TAURUS ENERGY

Response to Public Submissions - Conroy's Gap Wind Farm

A total of 22 submissions were received, 4 from Government agencies (DNR, RTA, DoL, CASA) and 18 from the community.

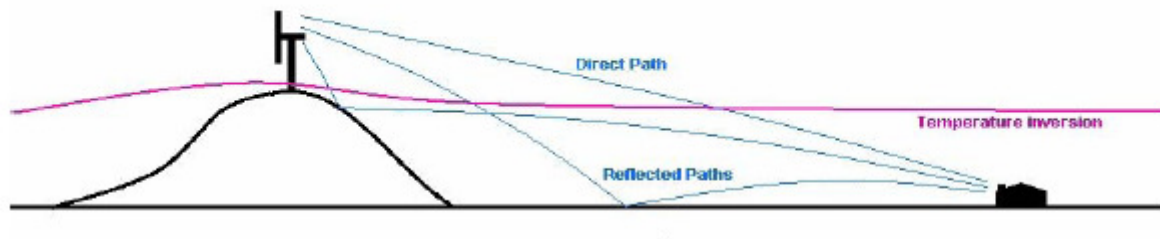
8-10. The proponent has failed to consider acoustic conditions in the context of the accompanying atmospheric and aerodynamic effects around the turbines.

It is assumed that this claim refers to the beginning of the discussion paper that depicts and explains the critical noise case:

- 1. It is night time and strong temperature inversion conditions prevail.*

- 2. The free stream wind velocity profile in front of the ridge reflects stable atmospheric conditions.*
- 3. Topographic features accelerate wind speeds over the ridge, boosting speeds at the turbine. Conditions above the ridge allow the turbine to operate at maximum power while dwellings downwind of the ridge remain in low velocity air*

- 4. Sound received at the dwelling arrives via a variety of paths*
 - a. Direct atmospheric propagation from the turbine*
 - b. Reflections from the ground*

5. Sound propagation from the turbine is assisted by the above conditions while masking of turbine noise by background noise is minimal or absent at ground level.

As shown in the diagram the temperature inversion would generally be below the height of the wind turbine.

Baseline monitoring of background noise levels was conducted during similar conditions and therefore account for low velocity air at ground level and are included in establishing baseline conditions.

Both paths are affected by the inversion, and sound refraction occurs as a result of both the temperature gradient and the wind velocity gradient. The intensity of both effects is linked and heightened by the meteorology. The result is that sound which makes its way below the inversion propagates as if in a two dimensional tunnel.

The diagram incorrectly shows the direct path as being un-affected by the temperature inversion. Compared to 'normal' atmospheric temperature gradient conditions the direct path would be bent downwards by the inversion and the result would be direct path noise would not propagate as far. Direct path noise at distance would actually be lower compared to 'normal' atmospheric temperature gradient conditions.

Refraction of the reflected path, whilst possible under such conditions, is unlikely to adversely affect wind turbine noise levels as the reflected path intensity is significantly lower than the direct path. The reflected path intensity is determined by the reflection loss, which is a function of the angle of incidence, ground hardness and ground cover and is frequency dependant. Generally the higher the angle of incidence the greater the amount of acoustic energy that is absorbed or lost during the reflection.

For the case of an elevated noise source such as a wind turbine on top of a local hill the direct path may not propagate as far as what it may under neutral conditions and the reflected path whilst it may propagate further, is generally of a lower intensity than that of the direct path. The net effect is that noise propagation under temperature inversion conditions would not be expected to be higher than under neutral conditions.

As discussed above, sound propagation of WTG's under these conditions is not expected to be assisted. During temperature inversion conditions it would be expected that wind induced noise at ground level would be low (as still conditions at ground level are expected). However, it should also be noted that under such conditions the noise level from other ground based noise sources (traffic on Hume Highway) can be significantly elevated, due to the enhancing effects the temperature inversion has on such sources which are below the inversion level. If background levels are raised as result of the temperature focussing noise from otherwise distant sources, then residual wind turbine noise would be further masked.
